August 18, 2022

Louis Casolo, P.E.  
Engineering Department  
City of Stamford  
888 Washington Blvd, 7th Floor  
Stamford, CT 06904

## Harbor Point- The Allure: P4 & P5- Local Slab Failure Final Report

WJE No. 2022.0759

Figure 4- Partially Collapsed 5<sup>th</sup> Level Slab. Looking East to West

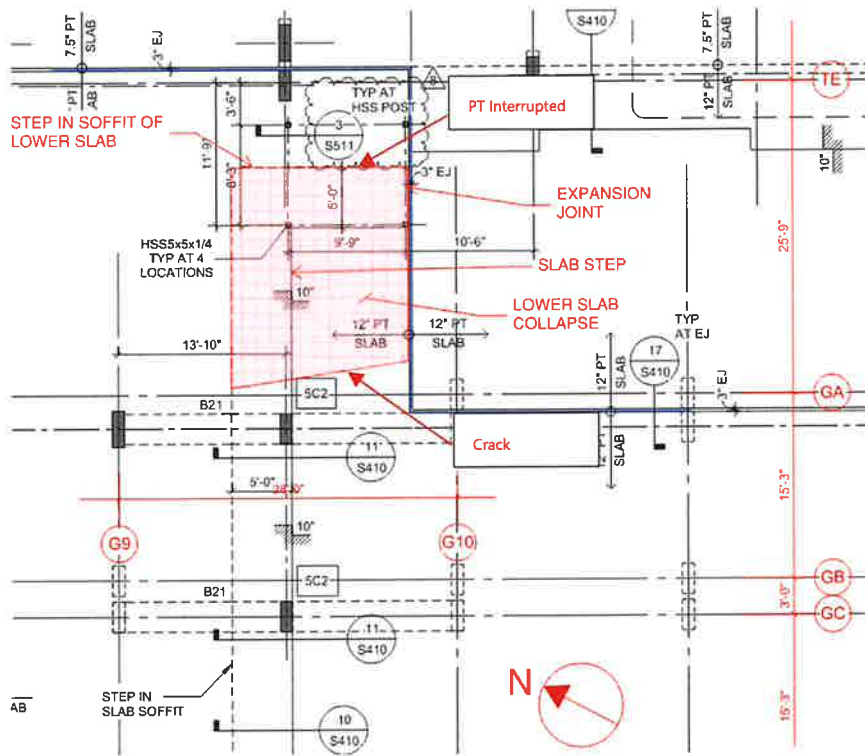
- The partially collapsed Level 5 slab measures 20 ft by 15 ft. It is a portion of the lower slab within the bay bordered by column lines G9/G10 and TE/GA. There is a crack in the west end of the slab and the east end of the collapsed portion of the slab is resting on the 4<sup>th</sup> floor level (Figures 7 and 8).
- The PT is not continuous as shown in the design and shop drawings at the slab step transition. The live (stressing) end anchorages were observed at the east end of the collapsed slab (Figure 9)
- There is a cold joint at the step in the slab at this location there is no reinforcement crossing the joint and the concrete is not roughened (Figure 10).
- Review of the failure plane indicates that there doesn't appear to be any reinforcing steel in the lower slab located higher than approximately 1-3 in. above the bottom of the slab (Figure 11 through 12).

Figure 14- Underside of lower slab to west of partial collapse. Arrow indicates 83.5 in. wide region where tendons were missing in collapsed slab. WJE could not scan because of Insulation.

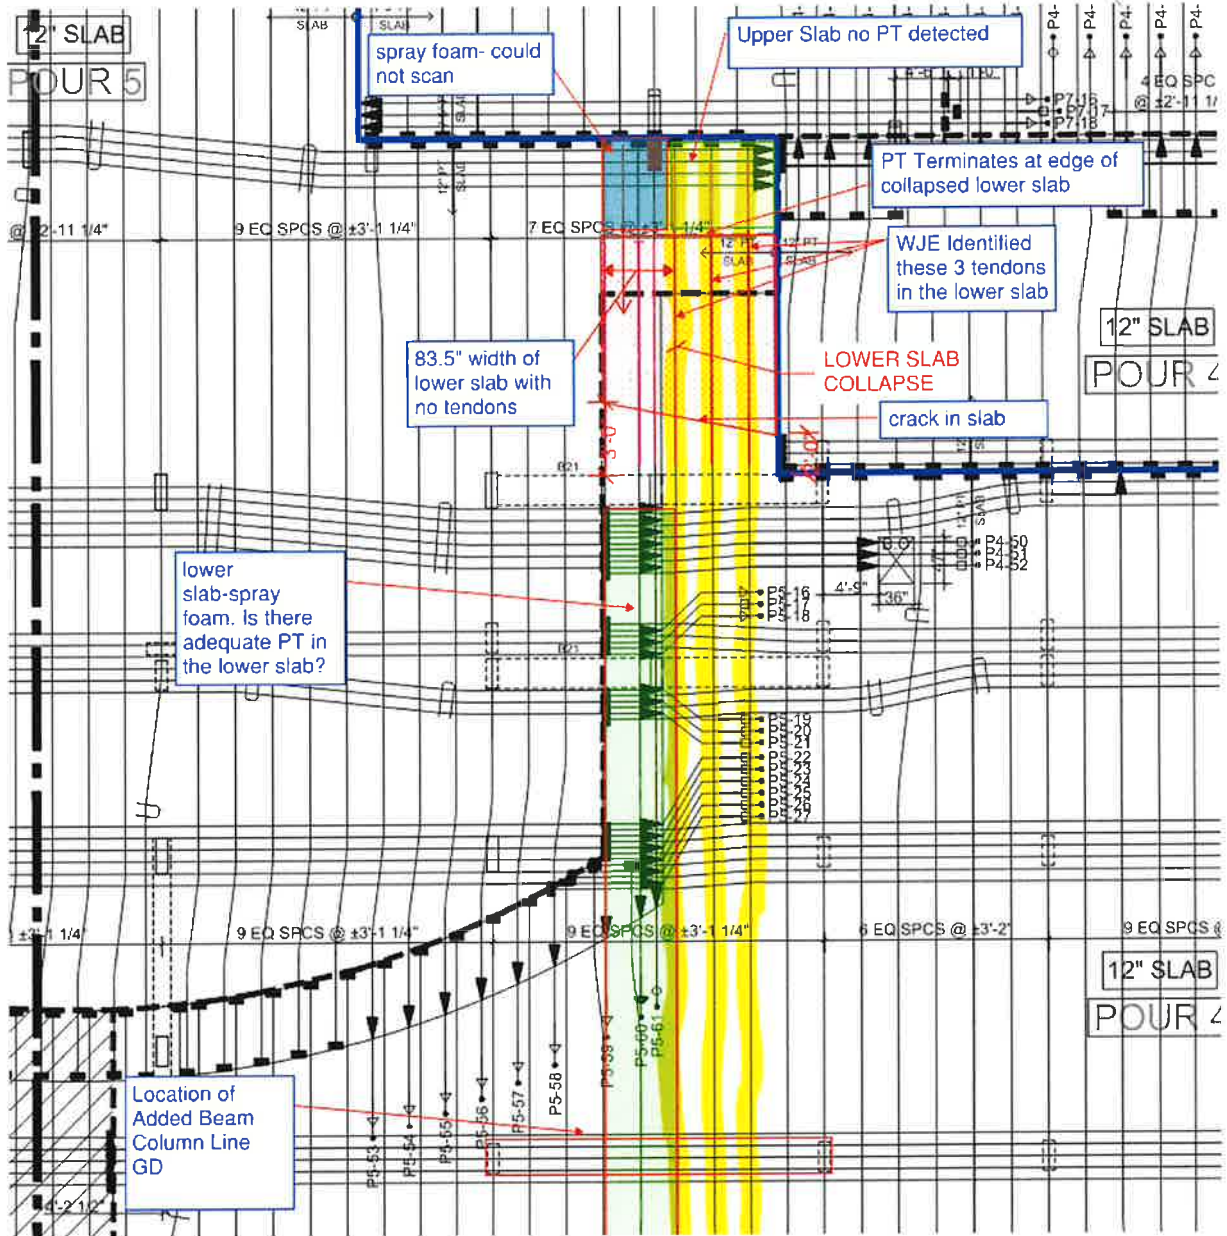
- WJE utilized a ground penetrating radar (GPR)<sup>4</sup> to identify the PT tendons and mild reinforcing in the east/west direction of the partially collapsed slab. Starting from the north end of the slab, the first band is approximately 14.5 in. from the edge and the next two bands are spaced at approximately 36 in. and 43 in. on center. This results in an approximately 83.5 in. section of the south end of the slab that does not have any tendons (Figure 10). Furthermore, WJE used the GPR to identify the tendons at the remaining west lower slab. The existing 3 bands of tendons span over the existing B21 beam at the GA column line and continue west. Due to spray foam insulation on the ceiling, WJE was not able to verify if there are additional tendons to the south outside of the failure area as none were visually observed at the failure plane. (Figure 13-15).

Figure 1- Partially Collapsed 5<sup>th</sup> Level Slab. Looking East to West

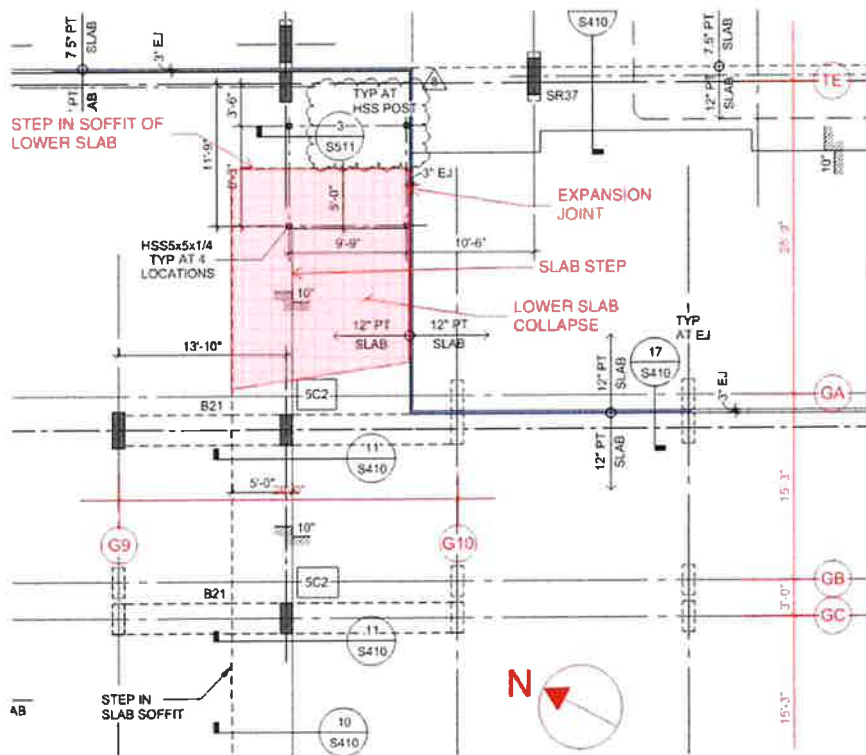
On February 1, 2022 a partial collapse of the 5<sup>th</sup> floor amenities level occurred. The collapsed area is approximately 20 ft. east/west by 15 ft. north/south and bound within column lines G9/G10 and TE/GA (Figures 1 & 2). The section of slab that collapsed is adjacent to a transition zone where there is a 10" step in the slab along the north and east sides. At the south edge of the collapsed area there is an expansion joint (Figure 2). The step in the slab allows for the installation of waterproofing and pavers at the top side of the amenities deck. The original design drawings indicate that the east/west spanning PT at this area was to be continuous through the slab step and the concrete slab construction was to be monolithic (Figure 3).

Figure 7- Construction Joint Between Upper and Lower Slab. East End of Collapsed Slab

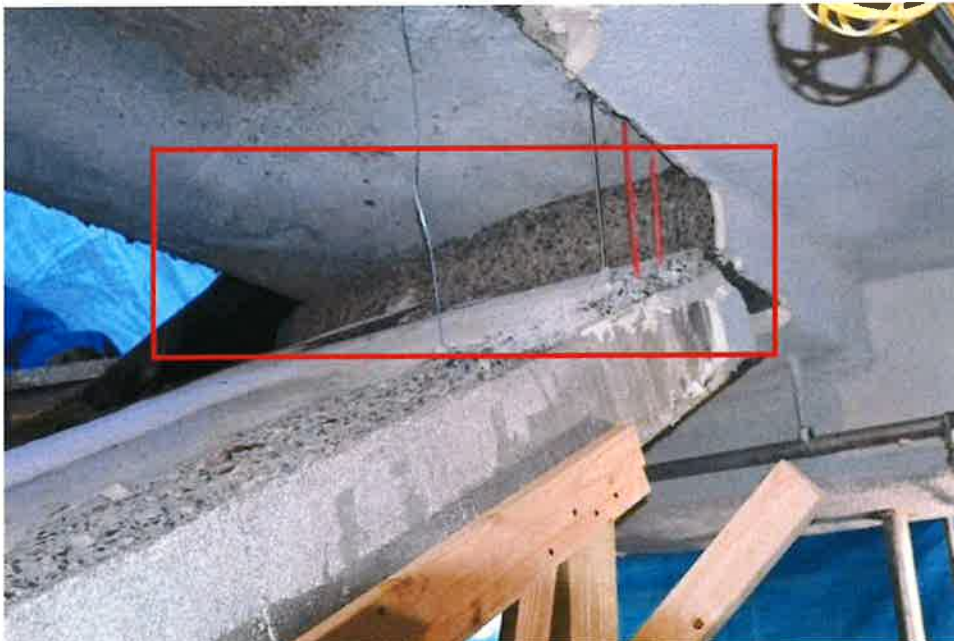
- There is a construction joint at the step in the slab at this location there is no reinforcement crossing the joint and the concrete is not roughened (Figure 7).

Figure 8- No top reinforcement at failure plane Northwest Portion of Collapsed Slab

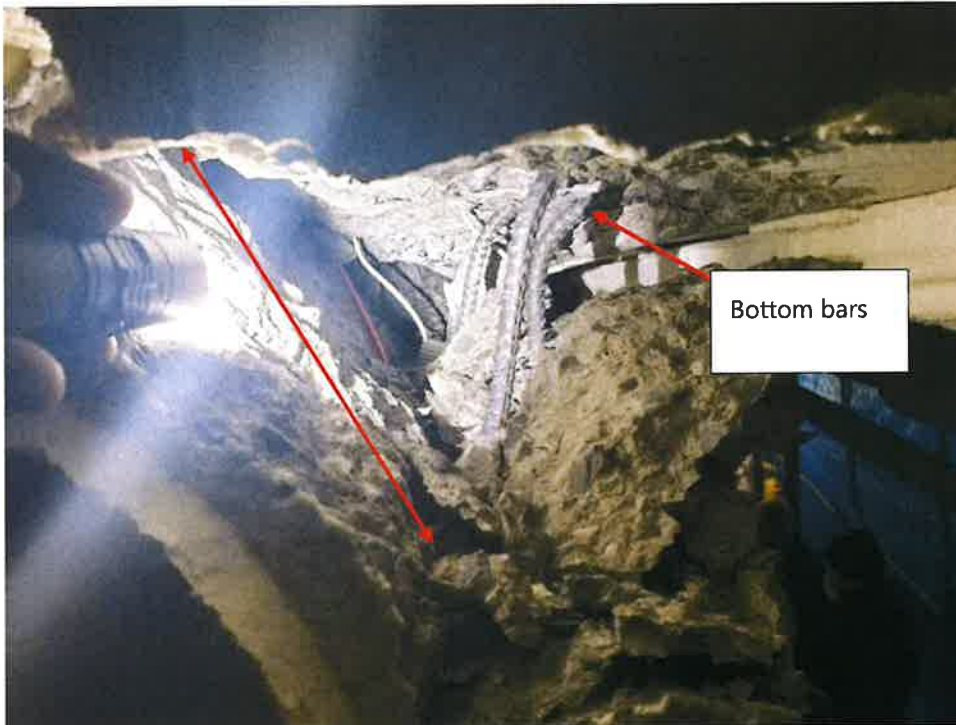
- Review of the failure plane indicates that there doesn't appear to be any steel in the lower slab located higher than approximately 1-3 in. above the bottom of the slab (Figure 8 and 9).

- For clarification, there is only supposed to be a #4 size rebar mat at the bottom of the slab in each direction. Additional top bars are provided at column locations in each direction. No, the EOR was not notified of any missing steel reinforcement prior to concrete placement, and we do not have special inspection reports for this location. Slab assessment for missing steel will be conducted in Phase 2 of the Work Plan.

HARBOR POINT  
BLOCK 2A, LPS  
SINGAPORE

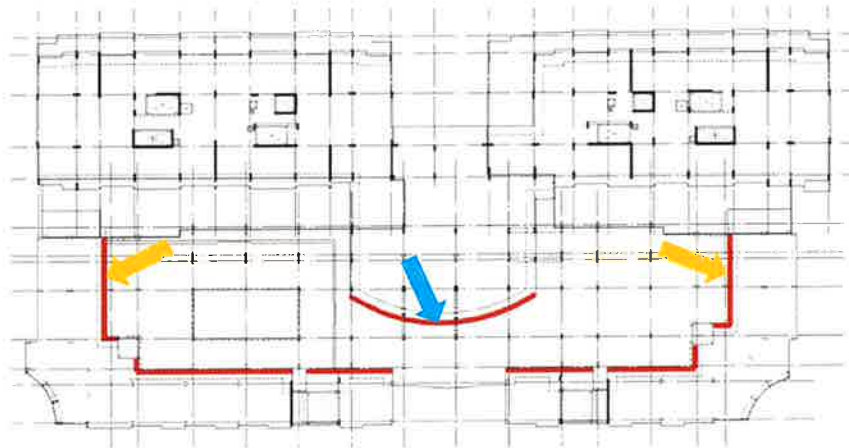
1. For slab steps highlighted red in Figure 1, the EOR's analytical approach appeared to be the following: The "upper slab" and "lower slab" were modeled separately. To simulate the support provided by the lower slab, the upper slab was modeled with a concrete wall at the location of the step, and the lower slab was modeled with applied loads (intended to be reactions from the wall) at the same location.

In the "upper slab" models, the wall was modeled with moment fixity at the slab connection (i.e. moments were not released). However, no applied moments were then transferred to the "lower slab" models (only vertical forces). This is analytically inconsistent and should be resolved.

2. As described above, "lower slab" models included applied loads at the location of the step, which were intended to simulate support of the upper slab. At the two slab steps indicated with orange arrows in Figure 1, these loads were not linearly applied as would be expected, but were instead point loads located at column locations only. This load application is not consistent with the "lower slab as a continuous support of the upper slab" analytical concept and should be corrected.

3. Similarly, for the slab step indicated with a blue arrow in Figure 1, the applied loads in the "lower slab" model appear somewhat light. In the "upper slab" model at this location, linear reactions at the slab step "wall support" are approximately 1500-2000 pounds per linear foot (plf) for "Dead Load" and 600-800 plf for "Live Load." In the "lower slab" model, applied reactions are only 1300-1600 plf for "Dead Load" and only 250-350 plf for "Live Load." These discrepancies should be resolved.

Figure 1. 5th Floor Overall

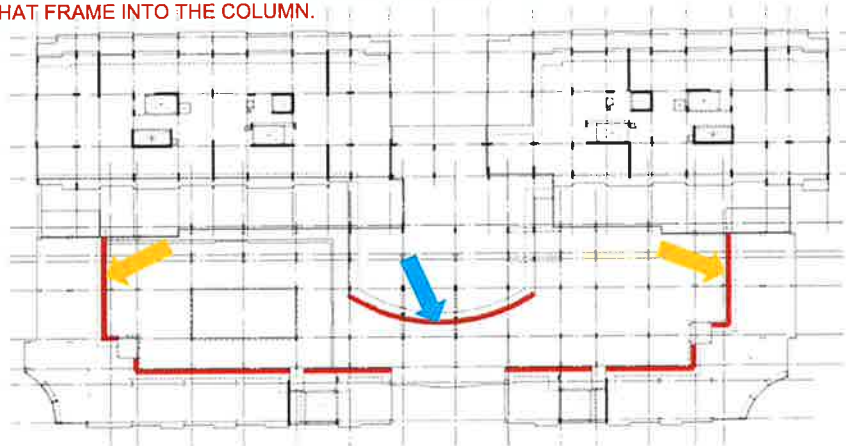
1. For slab steps highlighted red in Figure 1, the EOR's analytical approach appeared to be the following: The "upper slab" and "lower slab" were modeled separately. To simulate the support provided by the lower slab, the upper slab was modeled with a concrete wall at the location of the step, and the lower slab was modeled with applied loads (intended to be reactions from the wall) at the same location.

In the "upper slab" models, the wall was modeled with moment fixity at the slab connection (i.e. moments were not released). However, no applied moments were then transferred to the "lower slab" models (only vertical forces). This is analytically inconsistent and should be resolved.

2. As described above, "lower slab" models included applied loads at the location of the step, which were intended to simulate support of the upper slab. At the two slab steps indicated with orange arrows in Figure 1, these loads were not linearly applied as would be expected, but were instead point loads located at column locations only. This load application is not consistent with the "lower slab as a continuous support of the upper slab" analytical concept and should be corrected.

3. Similarly, for the slab step indicated with a blue arrow in Figure 1, the applied loads in the "lower slab" model appear somewhat light. In the "upper slab" model at this location, linear reactions at the slab step "wall support" are approximately 1500-2000 pounds per linear foot (plf) for "Dead Load" and 600-800 plf for "Live Load." In the "lower slab" model, applied reactions are only 1300-1600 plf for "Dead Load" and only 250-350 plf for "Live Load." These discrepancies should be resolved.

HRSE: THE MOMENTS WERE NOT RELEASE AT THE LOW SLAB SUPPORT CONDITION, THESE MOMENT VALUES ARE VERY SMALL AS THE UNIFORM CABLES ARE PARALLEL TO THE STEP AND TRANSFER THE FORCE TO THE BANDED CABLE THAT FRAME INTO THE COLUMN.
